Questions and Responses

C003623

Bayard Cutting Visitor Center Exhibits

A-550

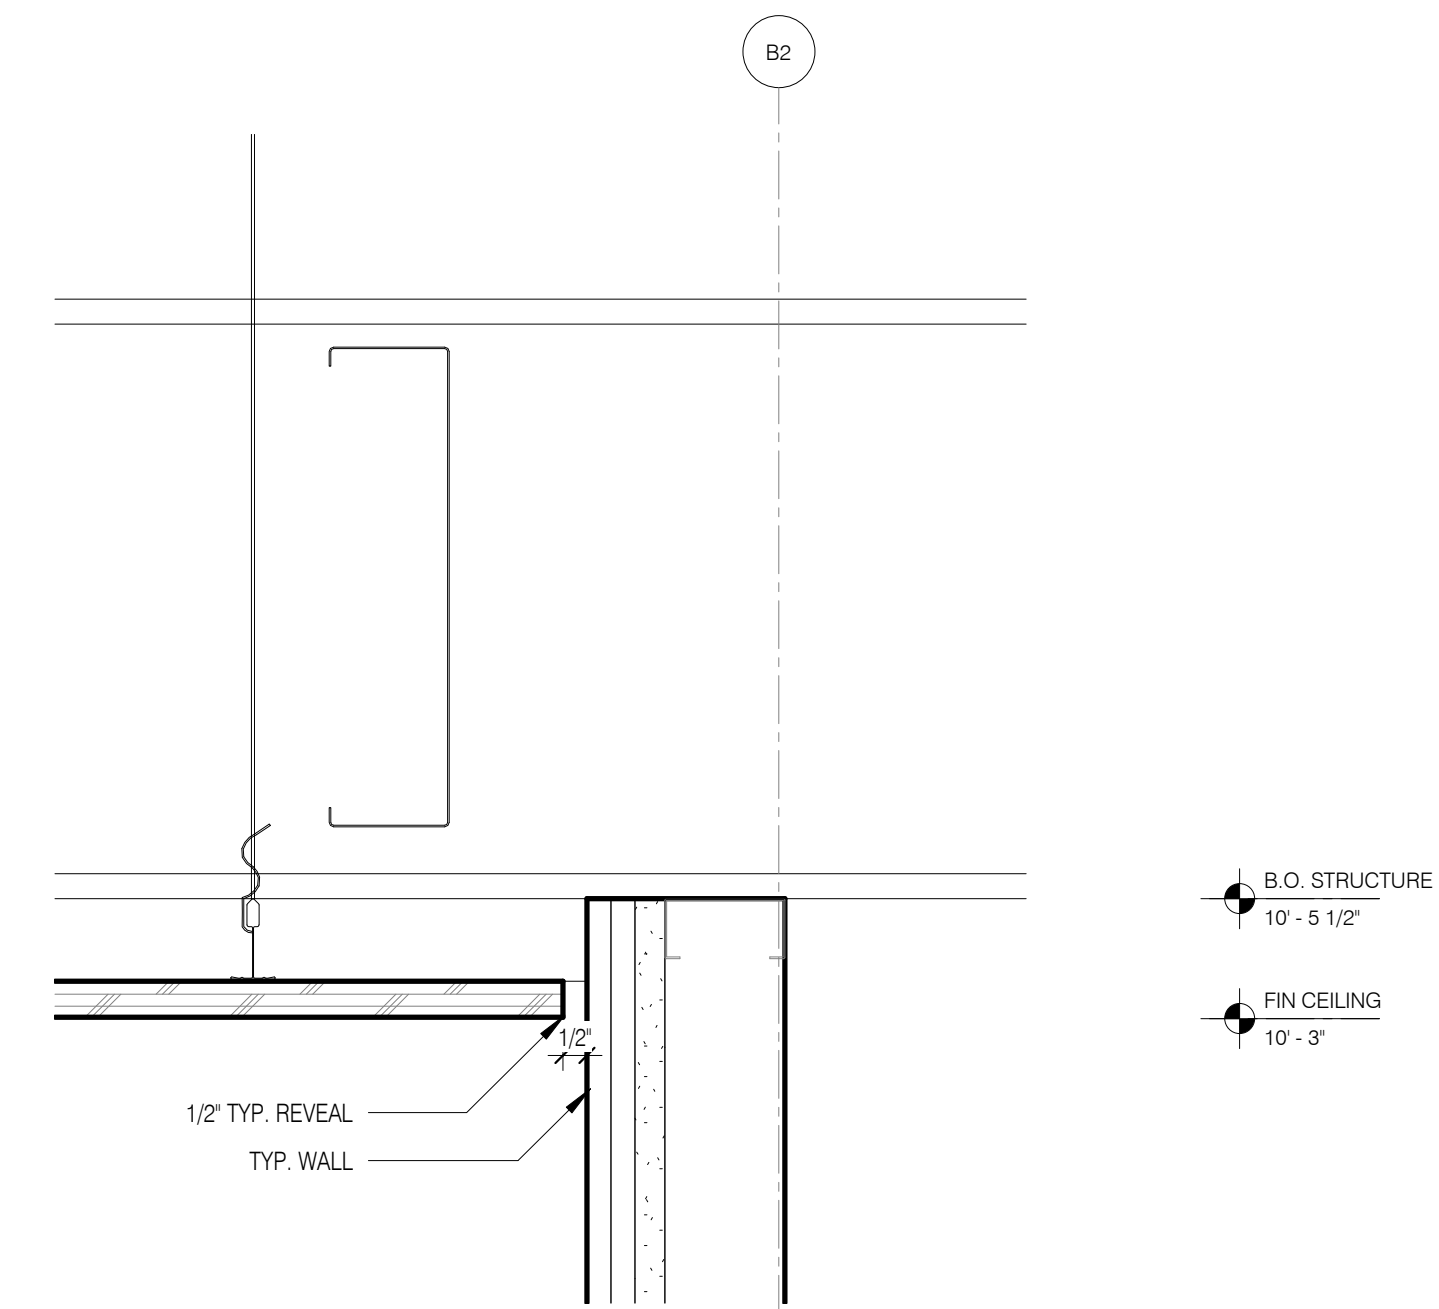
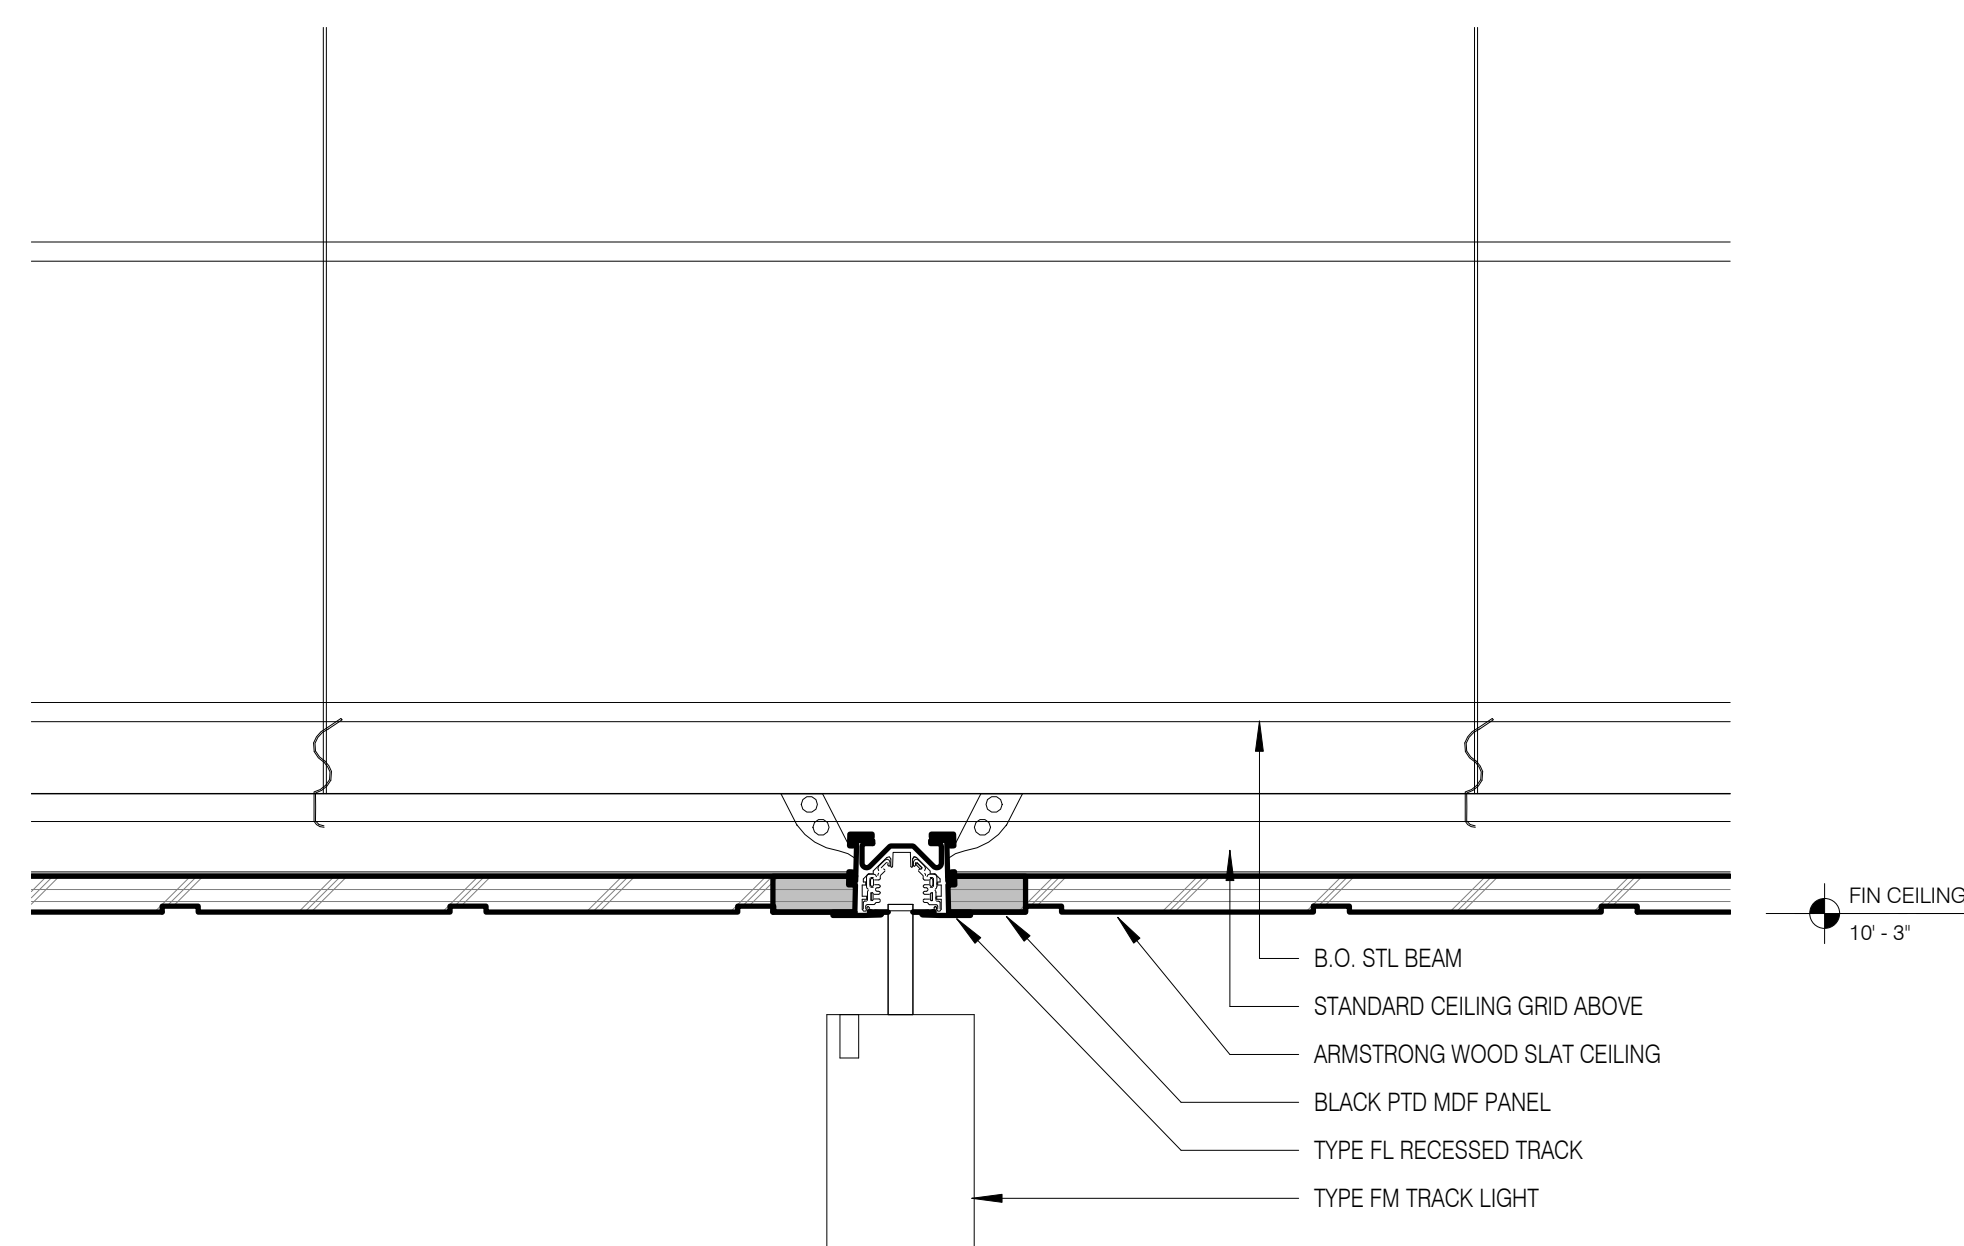
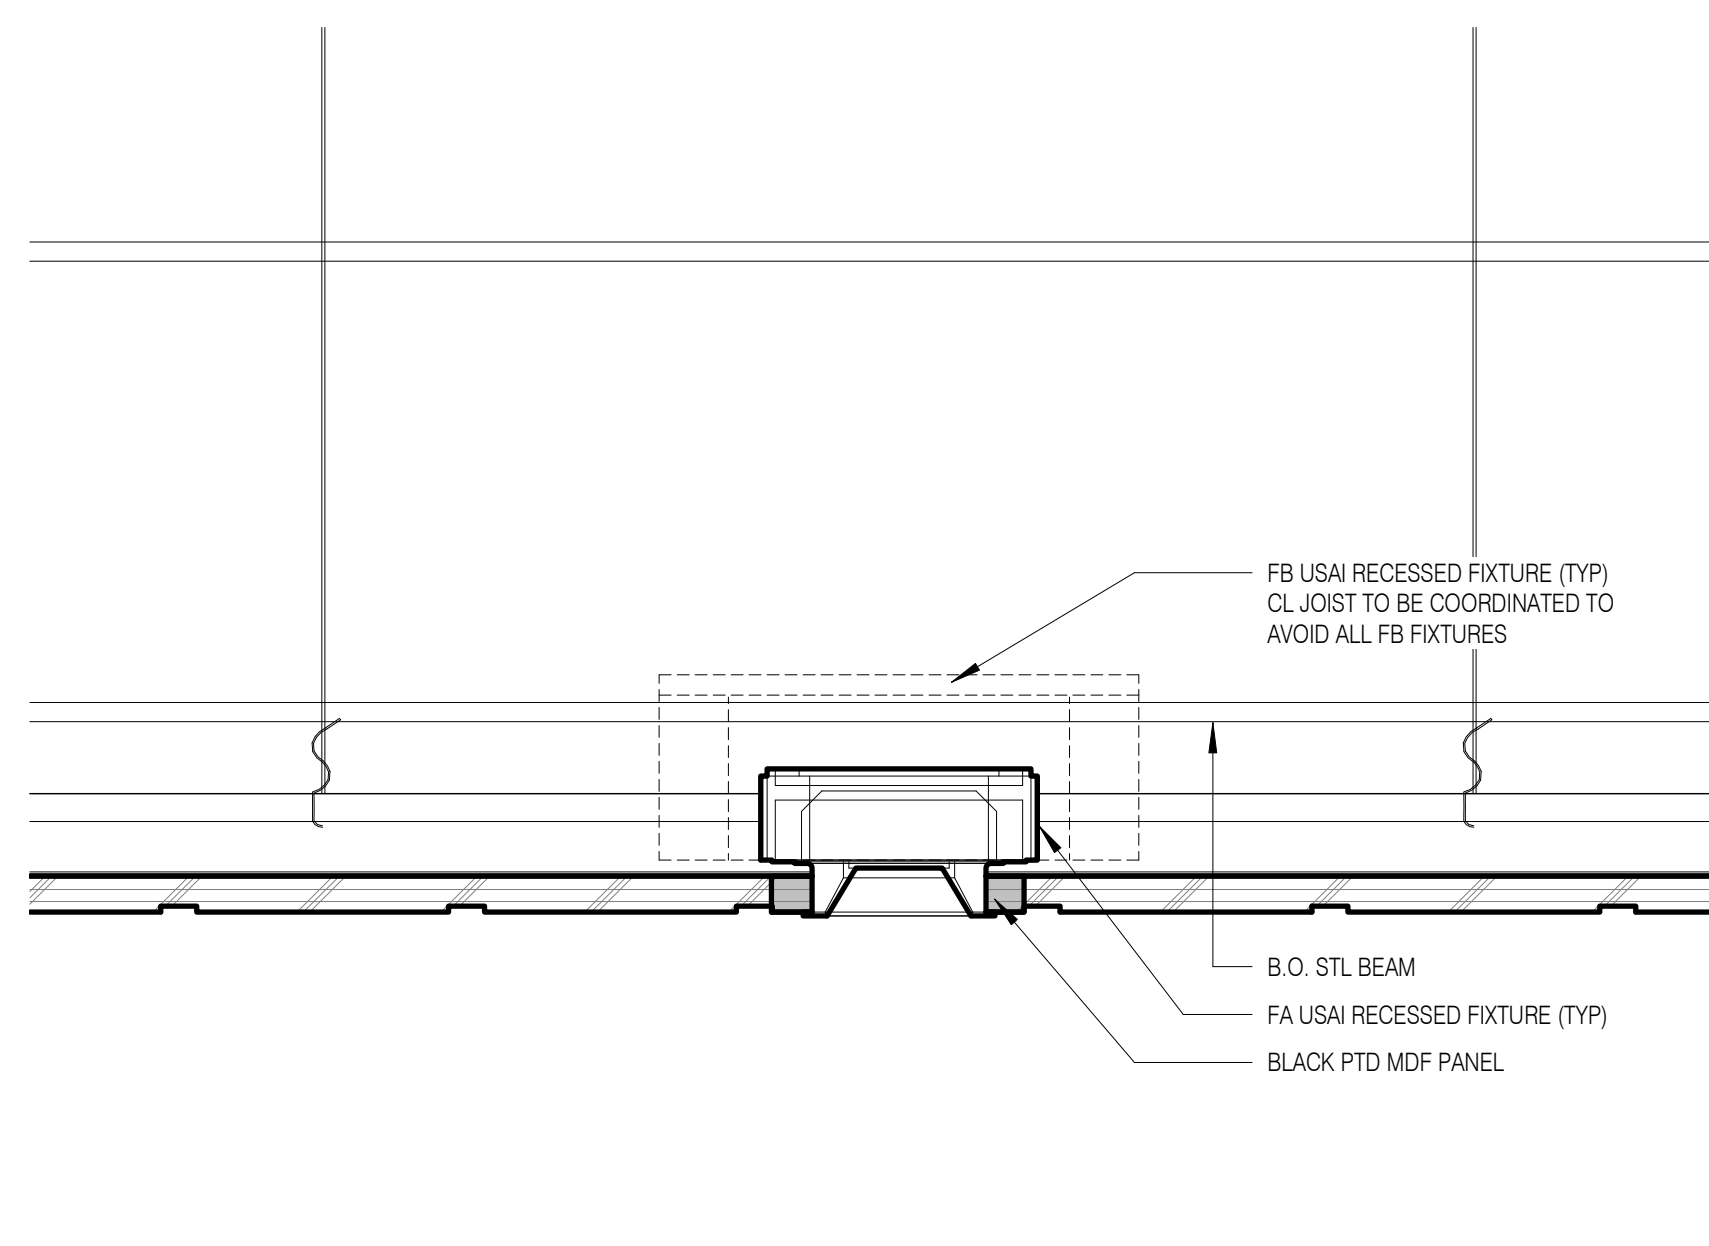
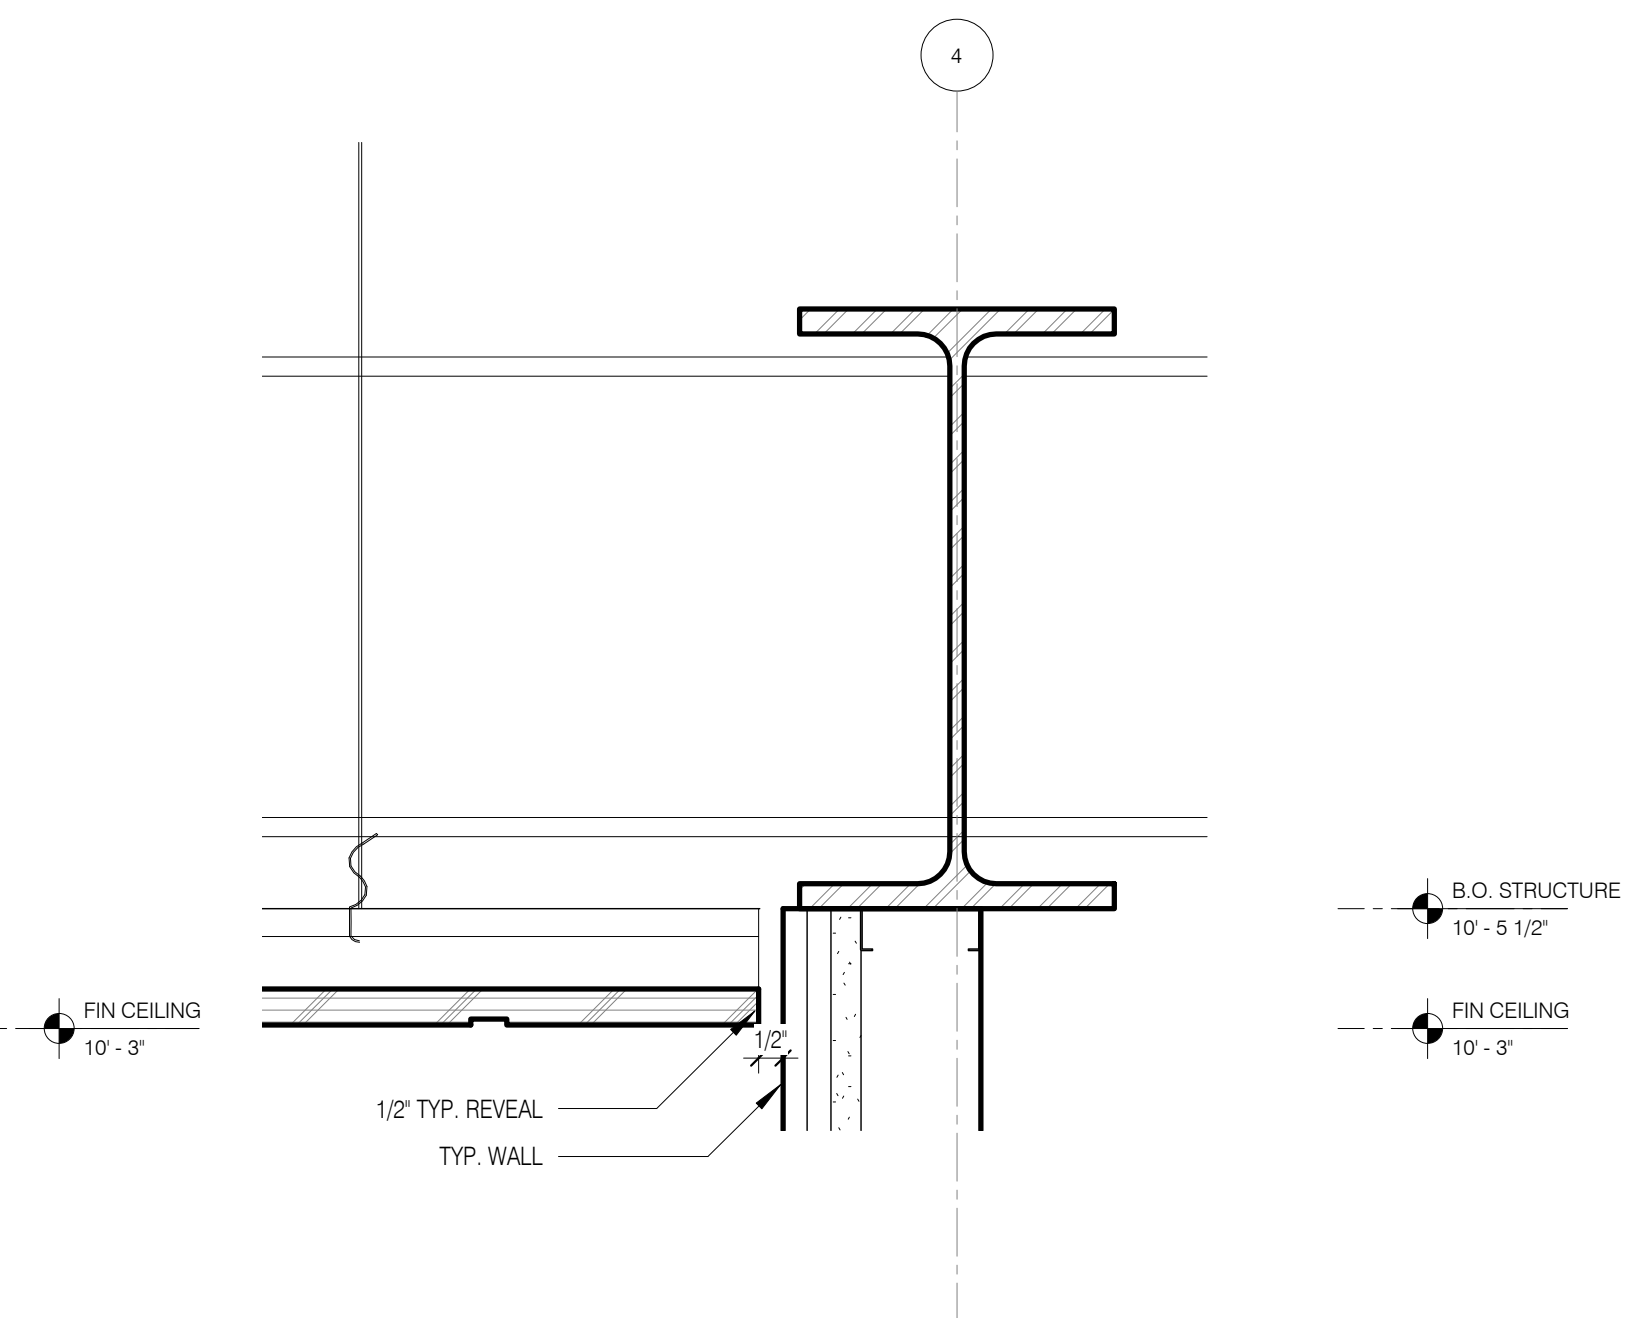
25	Exhibit A	X104	Our understanding of the drawings has the exhibit contractor responsible for providing: - Six LSI LX2030 fixtures, reflectors, and baffles and one Luxam Micro Track. - All the Luxam equipment in Exhibit 01: Museum of Trees - All of the Lusam equipment in Exhibit 02: Tree Science. Can you confirm?	Confirmed. Exhibit Contractor to provide (6) LSI LX2030 fixtures, reflectors, and baffles and (1) Luxam Micro Track, all the Luxam equipment in Exhibit 01 and Exhibit 02. All other light fixtures not in Exhibit Contractor scope.
26	Exhibit A	X100	Does the exhibit space and reception area have a drop ceiling?	Yes, A-550 will be provided for reference.
